81515-SRL-RP-YA-01-P2

Bridgewater Heights, Manchester – Acoustic Assessment of External Cladding Replacement

Figure 2 Extract from drawing BRID-DE-X-X-SK-Y-EWS-0003-P01 showing proposed wall build-up

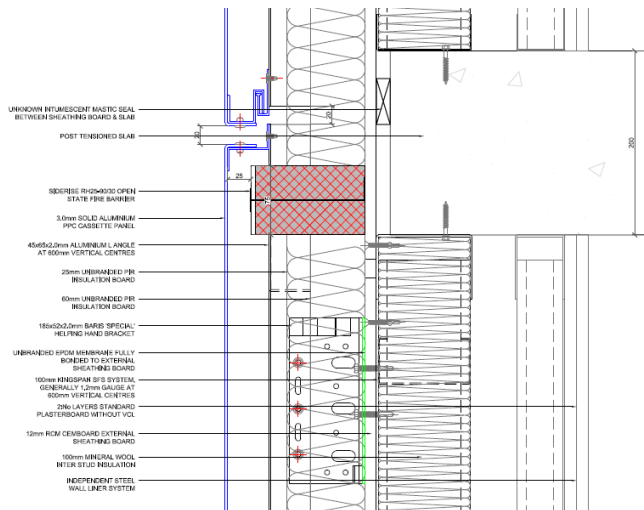
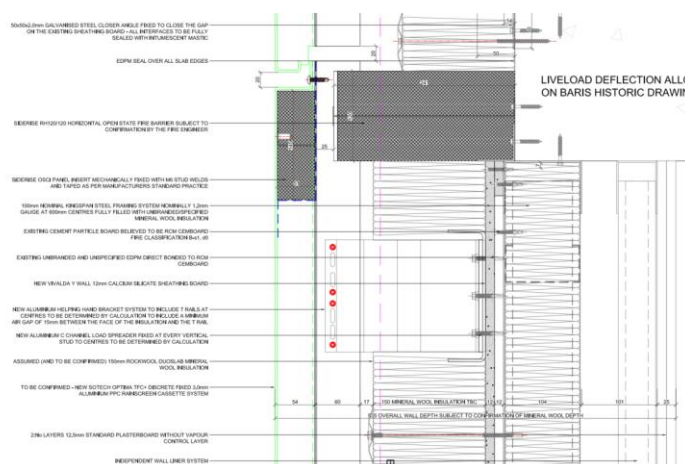
I understand that it is proposed to remove the existing external wall up to the SFS system (with the existing cement particle board retained to the rooms, but cut back at the slab edge) and then replace this with the following build up:

- 12mm layer of calcium silicate sheathing board fixed direct to the cement particle board.
- 3mm aluminium rainscreen cladding system installed on new bracket and rail system to create ~200mm cavity with 150mm Rockwool Duo Slab mineral wool insulation fixed back to the calcium silicate sheathing board.
- New Siderise slab edge closer at junction with concrete separating floors

The use of mineral wool in cladding systems inherently achieves a better performance than equivalent cladding build-ups with rigid (PIR) insulation. Furthermore, the increased mass per area of the sheathing board and cavity depth will also improve the sound insulation performance over the previous build-ups.

The rainscreen cladding systems are near direct replacements for the existing systems (albeit on deeper brackets) and we therefore assume the spacing of the new fixing brackets and rails will not be substantially different to those for the existing cladding systems.

The removal of the cement board at the junction with separating floors takes away a potential (albeit minor) path for vertical flanking transmission between flats.

- Any hole or gaps left in the cement board following strip out of the existing cladding system should be made good before the calcium silicate board is installed. Small fixing holes can be sealed with flexible mastic.
- There should be no gaps or weaknesses at the junction between the SFS sheathing and slab edge.

Figure 2 Extract from drawing BRID-DE-X-X-SK-Y-EWS-0004-P01 showing proposed wall build up

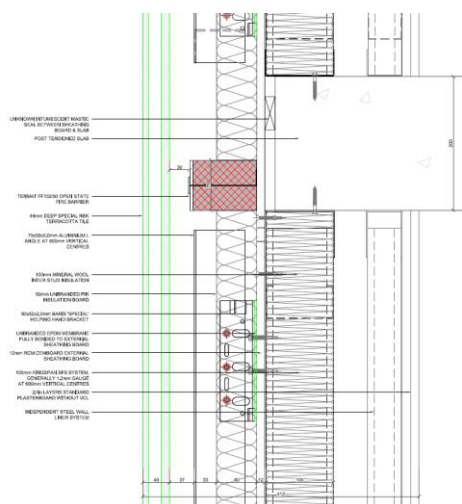
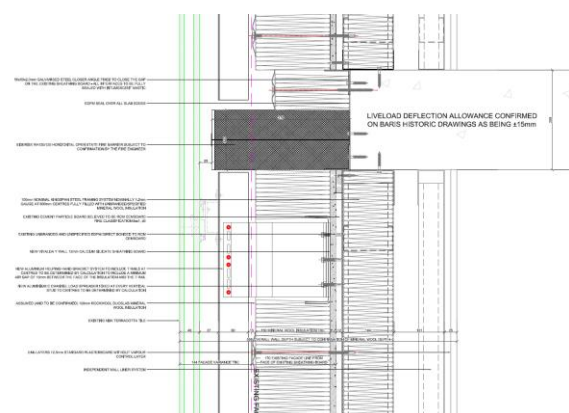
Again, I understand that it is proposed to remove the existing external wall up to the SFS system (with the existing cement particle board retained to the rooms, but cut back at the slab edge) and then replace this with the following build up:

- 12mm layer of calcium silicate sheathing board fixed direct to the cement particle board.
- 42 mm terracotta tile rainscreen cladding system installed on new bracket and rail system to create ~200mm cavity with 150mm Rockwool Duo Slab mineral wool insulation fixed back to the calcium silicate sheathing board.
- New Siderise slab edge closer at junction with concrete separating floors
